To: All U.S. and Canadian Volvo Retailers
Subject: Service Action S39820

**Service Action S39820: Engine Remote Start
Model Year 2016 – 2017 XC90 T8 Hybrid**

TITLE:
Service Action S39820: Engine Remote Start

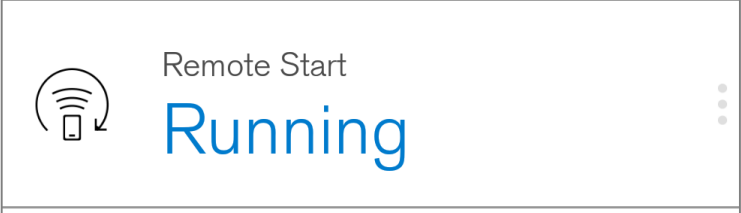
Use VIDA Vehicle Details Variant Attributes to confirm that Engine Remote Start is installed:

Not Installed: 2X01 REMOTE ENGINE START PRECOND Without Remote Engine Start Precond from smartphone app

Installed: 2X02 REMOTE ENGINE START PRECOND Remote Engine Start Precond from smartphone app
